# 1990 Corvette: Service Bulletin: ABS Code 63 Revised Diagnostic Chart

**Subject:** SERVICE MANUAL UPDATE SEC. 5E1 ABS DIAGNOSIS-  
REVISED CODE 63

**Model and Year:** 1990 CORVETTE

**Bulletin Number:** 90-430-5 - (08/21/1991)

**CODE 63**  
(PAGE 1 OF 3)  
**SOLENOID VALVE RELAY**  
(RELAY FAULT)

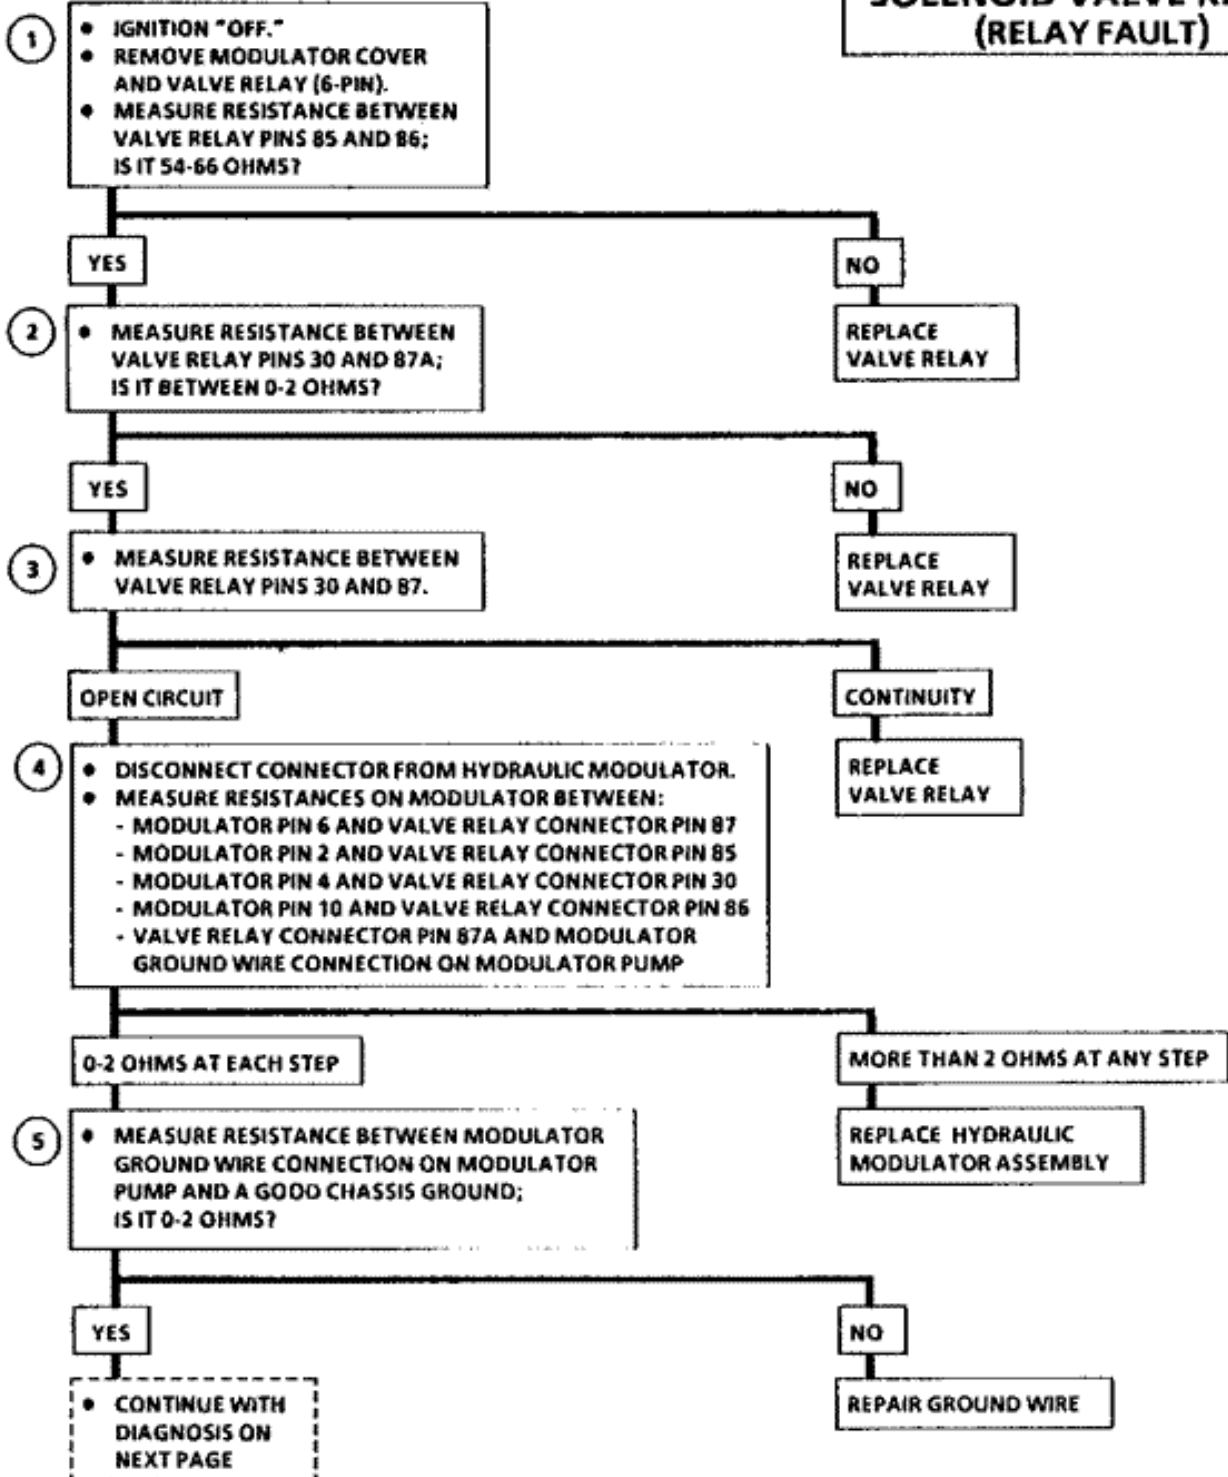
This bulletin serves to update the ABS Code 63 (Page 1 of 3) diagnostic chart on page 5E1-37 in Section 5E1 "Antilock Brake System Diagnosis" of the 1990 "Y" Service Manual. Please use the attached revised Code 63 (Page 1 of 3) diagnostic chart when diagnosing ABS Code 63 conditions on 1990 Corvettes.
